19/00038/COMPLY

**Land At Plum Orchard
Moreton Road
Longborough
Gloucestershire**

**Compliance with Conditions 5, 6, 7, 8, 13 and 14 of Permission 17/00321/OUT -
Development of up to 14 dwellings, public open space, landscaping and other
associated works (Outline application) at
Land at Plum Orchard
Moreton Road Longborough**

Compliance with conditions application 19/00038/COMPLY	
Applicant:	Piper Homes
Agent:	Zebra Architects Ltd
Case Officer:	Martin Perks
Ward Member(s):	Councillor Julian Beale
Committee Date:	13th March 2019

Drawing No. **8160293/1200** Rev **A5**

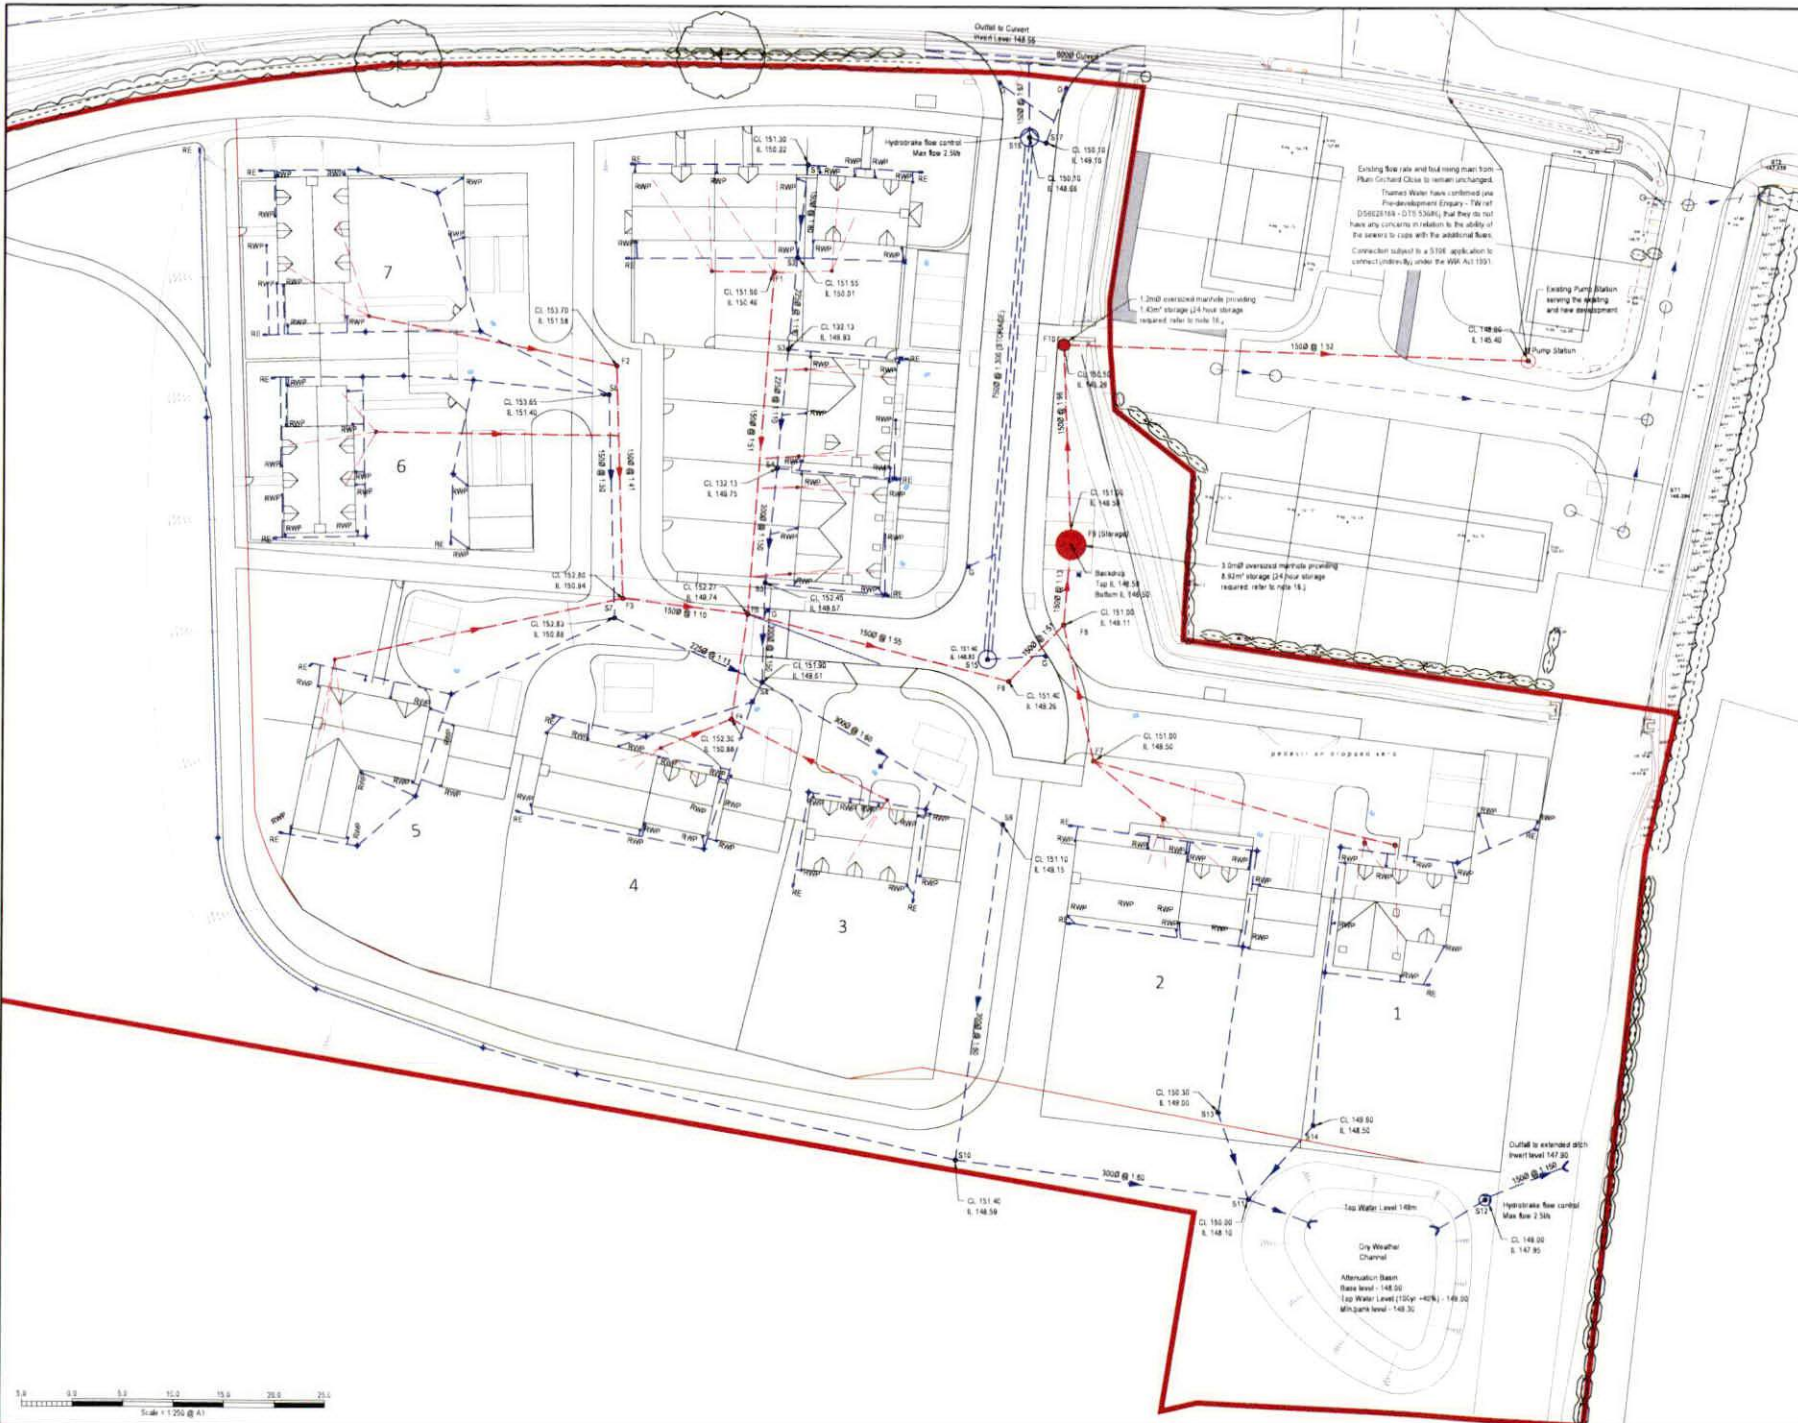
Concerns have been raised by local residents about the proposed drainage arrangements. Particular concern has been raised about odour arising from both the existing pumping station and the mains connection on Charlesway. Concern has also been raised about the management/maintenance of the existing pumping station. There is concern that the flow of additional foul water into the pumping station will exacerbate an existing problem.

- 24 hour storage is to be provided above the high level alarm of the pump station at Plum Orchard Close. The foul drainage strategy involves providing a gravity connection to the existing pump station. Refer to Calculations sheet for details of existing and proposed 24 hour storage.

In relation to condition 8, our objection concerns the inadequacy of the construction detail provided, in particular:

1. We have seen some correspondence between Piper Homes and Case officer Martin Perks but are concerned that Piper Homes may not be fully informed about the nature of the flow problems. Piper say "It is incorrect that Bromford has not been maintaining the system, they have tried to improve it where they are able and regularly maintain, however, they were working with a system that by design was not going to work until it was properly supplied with effluent". We do not demur from the concept that increasing flow should improve the function of the existing plant. Furthermore, we do not possess the technical skills on this matter, but we have serious doubts about maintenance of both the existing and new systems as there is ample evidence of slow or non-existent response to the existing alarm system which requires someone to telephone a number posted on the plant compound. We would therefore wish to see a condition requiring an automated alarm system connected to the actual maintainers of the system who, no doubt, will be contractors yet to be appointed and a response time should also be formalised. System failure will impact on not only the new dwellings but, importantly, take the form of surface outflow of sewage into the lowest parts of the existing development.

2. Pump failure has been an issue and needs to be investigated and appropriate remedy settled before consent/compliance is agreed.
3. Bromford have blamed their tenants for flushing sanitary products into the system. As the blockage occurred at the outflow from the existing tank this may not be the case but should be entirely negated by a condition requiring macerator[s] at the inflow points to the tank so that this becomes impossible. We accept that little can be done about entry of these products to the pipe system from the new and existing individual dwellings [beyond exhortation] but certainly a unit should also be provided above the entry point to the new storage tank, too.

In response to these concerns, it is of note that the pumping station originally installed on the Plum Tree Close site is larger than that required to serve the 9 dwellings currently on the development. The pumping station is designed to accommodate a greater flow rate than that currently occurring. The odour issue arising from the existing pumping station results primarily from inadequate flows through the system. There is a slow turnover of effluent within the wet well of the pumping station with the result that it is becoming septic and releasing an odour. The introduction of additional waste flows into the pumping station will increase the rate of flow through the system. As a consequence, effluent will not be held within the pumping station for such long periods which will in turn reduce the level of odour arising from the machinery. In addition, the applicant is also proposing to install storage tanks within their application site which will provide a 24 hour emergency storage facility in case of maintenance issues arising at the pumping station. A 24 hour remotely monitored alarm system will also be installed which will alert the management company of any issues as soon as a drainage problem arises. At present, issues are dealt with when complaints are made by existing residents. It is considered that the proposed details are acceptable.

1. I totally agree that an alarm system that relies on a resident calling a number is now very out of date and I believe that this has been the main cause of the issues experienced at the Plum Tree Close. Blockages have occurred and the alarm has gone off, but residents have only noticed when the emergency storage has filled up and there is a real problem. As such, we will install a 24-hour remotely monitored alarm system which will alert the pump company as soon as there is an issue. This will mean that reaction time is immediate and the emergency storage provided is used correctly i.e. allow time for the engineers to get to the site.

2. We will fully service and upgrade where necessary the pumps and system. This will be based on recommendations by an independent pump company and I am happy to provide the council with evidence that these works have been implemented and signed off by the pump company.

3. I have discussed this with a pump company and I am afraid that it won't work. A macerator will create another point of failure within the system which if blocked will cause a backup on the wrong side of the pump unit where there is no emergency storage facility meaning that effluent will backup straight into the properties. Your suggestion of a remote alarm will resolve any blockage issues as they will be able to be dealt with immediately and correctly whilst having the emergency storage facility there which will function so that there is no back up of effluent into the dwellings. Not only is there emergency storage already provided we are providing additional storage on our site as a fail-safe.

Drawing No. 8160293/1100 Rev A6

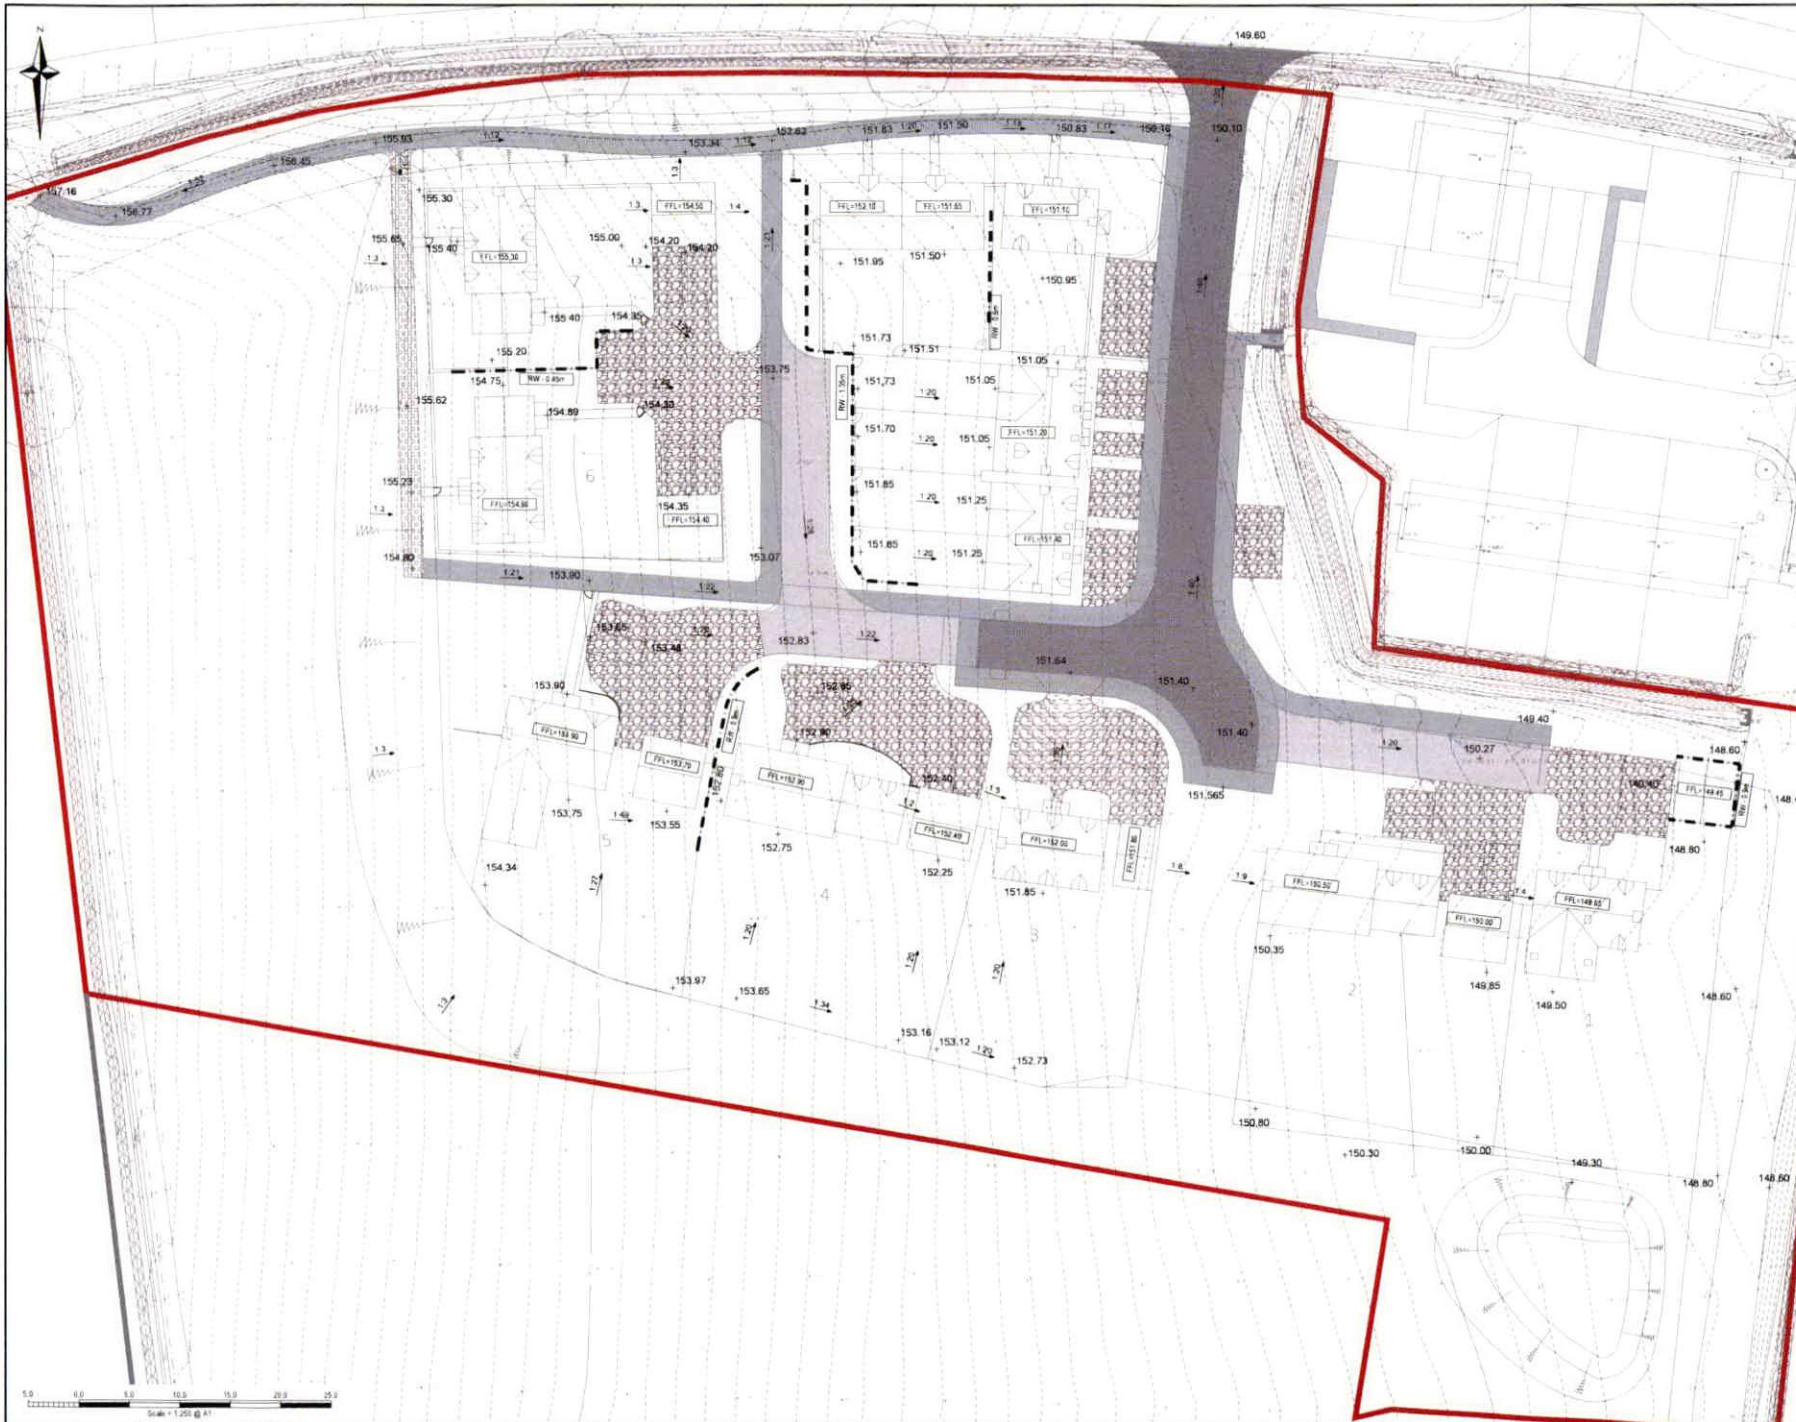
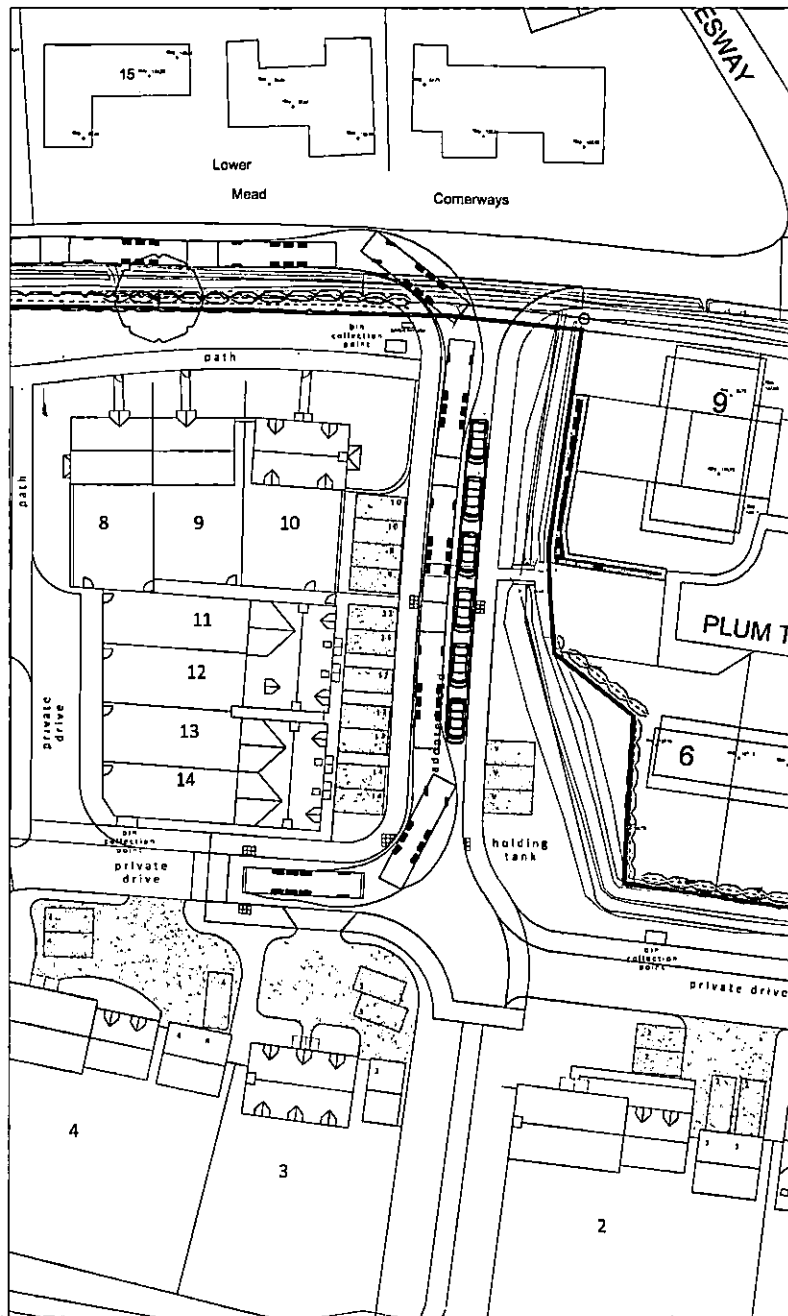
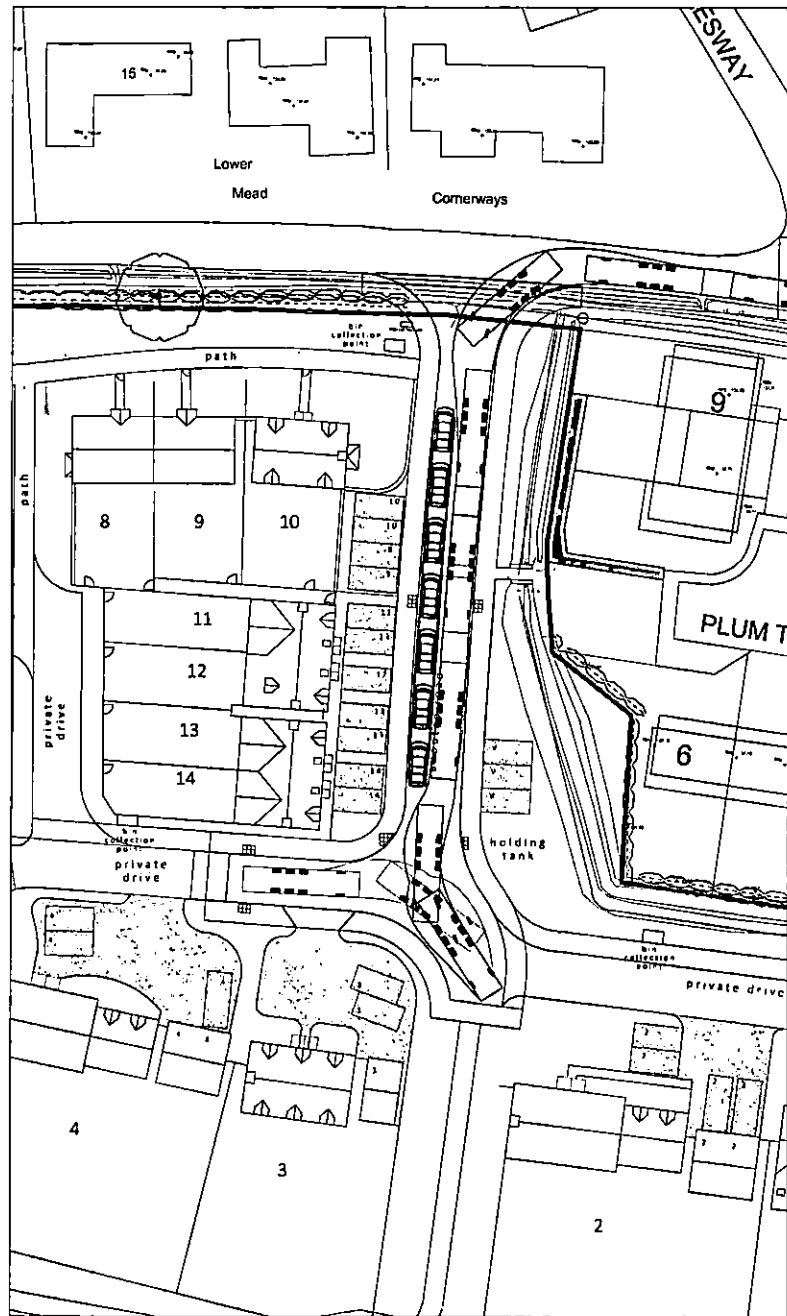
So far as condition 14 is concerned, the external works plan shows a path round the back [south and west] of the new development. Whilst we doubt the necessity for this as no occupier is going to take this longer route, the short section across the area intended to pass to the responsibility of the Parish Council, is positively deleterious to the use of the open space for team games such as football, which requires a rectangular open space; this ought to be removed. The Parish Council supported the inclusion of such play space in the overall scheme, as there are currently no play facilities in the village for this kind of sport for older children. A footpath running across the grass would effectively render it unusable for sport and impose a financial burden on the council for grass cutting without the attached benefit of it creating play space of the kind identified as in need for the village on the Development Plan.

The applicant has provide a site layout plan which shows the creation of an asphalt footway leading from the site entrance to the Public Right of Way in the north western corner of the application site. The surfacing of the footpath is considered appropriate for all types of users.

I believe that we have amended the plans to take on board the comments made by the Parish Council.
